Voluntarily Scheduled Resource Guidelines

Part of the Integrating price-responsive resources (IPRR) rule

Draft Report – Standard consultation
for the National Electricity Market

Published: 03 June 2025

Figure 4 South Australia region proposed VSR zones

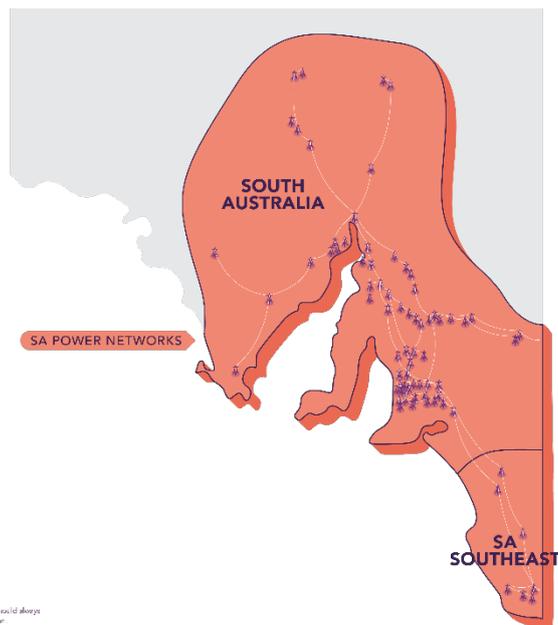
AEMO has also further considered the 13 proposed VSR zones from the consultation paper. AEMO now considers that it can amalgamate two of the South Australia zones to result in a total of 12 VSR zones as outlined in Table 6 above. Figures 2-6 below provide visual representations of the VSR zones against the representative distribution network areas.

AEMO proposed 13 congestion-based VSR zones in its consultation paper. AEMO now considers that it can amalgamate two of the South Australia zones, as shown in Figure 3 and established in the Draft Guidelines.
